McCULLOCH CORPORATION
SERVICE BULLETIN

1537

MODEL: All Mini Mac Chain Saws March 23, 1973

SUBJECT: FUEL HOSE INSTALLATION

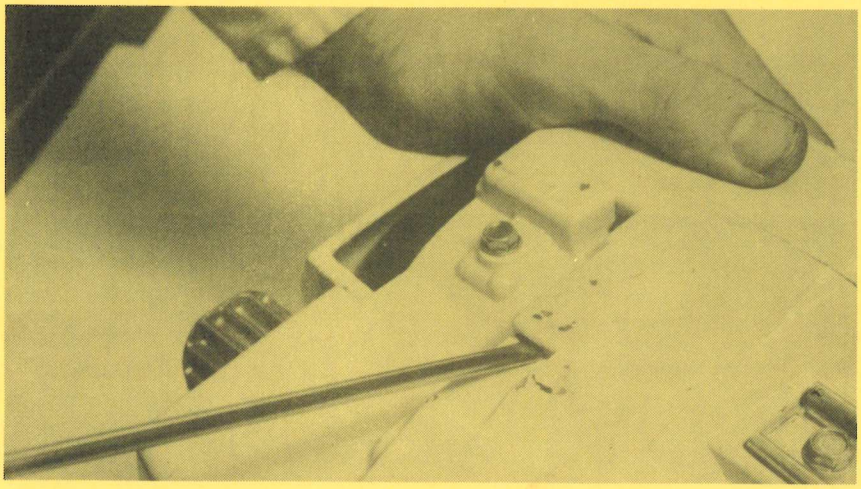
To insure proper seating of the Mini Mac fuel hose to the fuel tank, a small amount of grease may be applied to the fuel hose guide ribs in the bottom of the fan housing. This will allow the hose to slide into position against the ribs and prevent kinking when the fuel tank is installed.

If there is evidence of fuel starvation, loss of power, lean running condition, or erratic carburetion, a kinked fuel hose may be the problem. To make sure the hose is properly seated, tug on the fuel tank before the front cover is installed and feel the resistance of the hose. Install the front cover.

Look inside the access hose in the bottom of the fan housing and see if the hose is straight. Insert a screwdriver and push the hose forward into the tank.
